VIRGINIA ELECTRIC AND POWER COMPANY
RICHMOND, VIRGINIA 23261

VIRGINIA ELECTRIC AND POWER COMPANY (DOMINION)
NORTH ANNA POWER STATION UNITS 1 AND 2
PROPOSED IMPROVED TECHNICAL SPECIFICATIONS
REQUEST FOR ADDITIONAL INFORMATION (RAI)
SECTION 3.3, "INSTRUMENTATION" (TAC Nos. MB 0799 and MB 0800)

**Proposed Improved Technical Specifications
Responses to Requests for Additional Information
ITS 3.3, "Instrumentation"**

North Anna Power Station Units 1 and 2

ENGINEERED SAFETY FEATURE ACTUATION SYSTEM INSTRUMENTATION

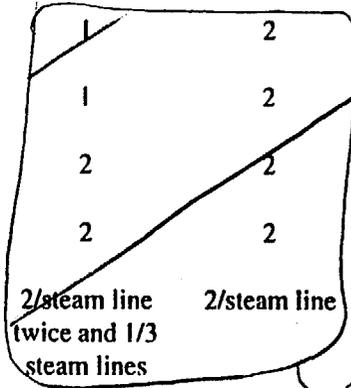
RAI 3.3.2-8: Comment: The CTS discussion of "channels to trip" is provided in the TS Bases. Provide an LA-DOC justification for this change to CTS.

Response: The Company agrees with the Comment. A less restrictive removal of details DOC LA.12 justifies the movement of the information to the UFSAR. DOC A.5 has been modified to address the administrative change of the CTS columns.
